*Southern California Edison*  
*2025-WMPs – 2025-WMPs*

**DATA REQUEST SET CalAdvocates-SCE-2025WMP-09**

**Overhead Detailed Inspection – 2023 Results**

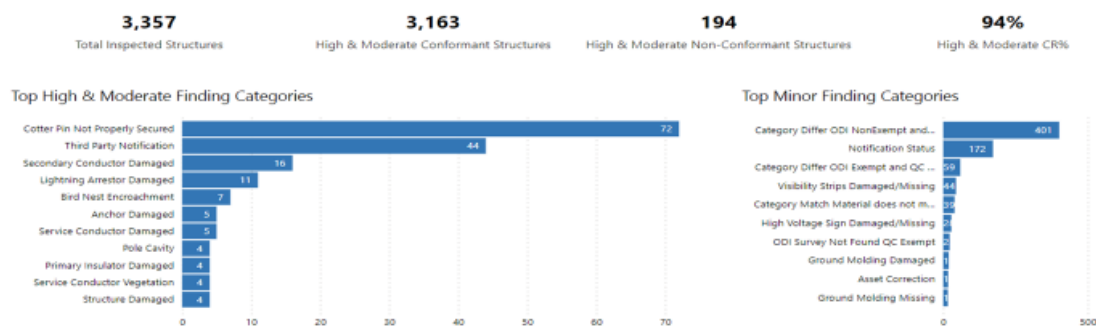
QC inspectors identified 72 structures where the initial asset inspection missed a "cotter pin not secured properly" finding.

- Provide a description of the "cotter pin not properly secured" finding category.
- Provide a photo example of a cotter pin that is not properly secured.
- What is the corrective action for the cotter pin finding?
- What specific measures is SCE implementing to address the cotter pin findings

Please see the attached Heads-Up Bulletin (file name: *HU-2023 1723 Cotter Key Pins\_Redacted.pdf*) that was published and distributed on 10/17/2023. Employee names have been redacted. The bulletin was used to inform SCE and contractor personnel of the proper installation of clevis pins and cotter keys and the appropriate priority ratings for missing and incorrectly installed keys. This bulletin describes the issue, provides guidance for priority ratings, and provides pictures. The information in this bulletin along with information regarding QC findings was communicated to SCE and Contract personnel during monthly meetings and used by the inspections group for

training inspectors. Findings identified during the QC review are corrected by the business lines, either by remediating the finding or by providing a notification showing that the finding has been scheduled for remediation.
